WICHITA—SEDGWICK COUNTY

METROPOLITAN AREA PLANNING
COMMISSION

Re: S/D 85-18 - Final Plat of Hatstrup Addition

RE: DP-159, Amendment #1 - Hattrup Residential Community Unit Plan Proposal - Generally located west of Webb Road and South of 29th Street North.

**HATTRUP COMMUNITY
UNIT PLAN AMENDMENT
(FORMERLY HATTRUP C.U.P. D.P. 159)**

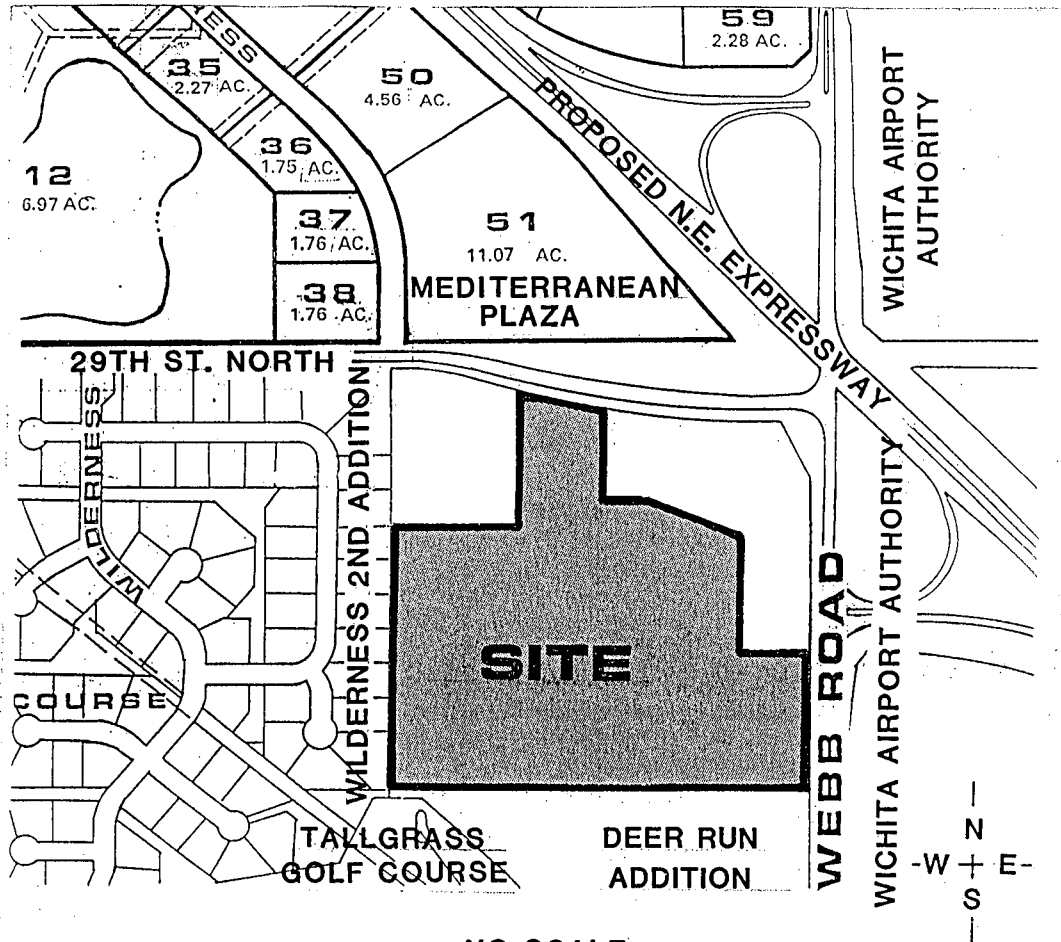
- (1) As requested on the church plat to the west, the C.U.P. drawing should indicate the standard required right-of-way for 29th Street North of 50-feet of half-street r.o.w. tapering to 75-feet at the intersection. The r.o.w. for Webb should be 50-feet and not 60-feet as shown.
- (2) The access control along Webb for the adjacent property requesting "LC" zoning should have an area of complete access control across the street from the on-off ramp for the Expressway. This access control shall be dedicated at the time of platting the commercial property.
- (3) General Provision #11 should indicate that turnarounds shall be provided for all streets longer than 150-feet.

General Provision #13 should include the following comment regarding parking requirements:

Since significant drainage occurs on this property and the existing lakes are indicated, the following drainage comment is needed:

Please include the following three comments regarding requirements for the recreation facilities and include "community facilities" as a proposed use for Parcel No. 1:

Off-street Parking - Parking shall be provided in accordance with Section 28.04.140 et seq of the code of the City of Wichita. If the street is designed with parking restrictions, a restrictive covenant requiring 4 spaces per dwelling unit will be submitted at the time of platting. Parking for the Clubhouse/swimming pool complex shall be provided as described below in parcel descriptions.

Any proposed drainage facilities, lakes, detention facilities, drainage ways, swales, etc. shall be designed in conformance with the hydrology study as prepared independently from this document. Results of this study and proposed drainage facilities shall be submitted for approval at the time of platting.

Parking - Since the Clubhouse/swimming pool complex is designed for use only by residents of this development and their guests, the off-street parking requirements are established on the basis of 1 space per 200 sq. ft. of structure or 1 space per 100 sq. ft. of pool surface, whichever is greater.

Screening - The Clubhouse/swimming pool complex shall be landscaped to provide for plant material screening to enhance views into the complex and to screen objectionable views such as pool equipment. Low level (30") screening shall be provided in conjunction with conifers and deciduous trees around parking lot to reduce impact of parking facility.

Security Fencing - The swimming pool proper shall be fenced for security purposes with fencing at least 5' high. May be constructed of open wrought iron, wood or masonry or combination thereof.
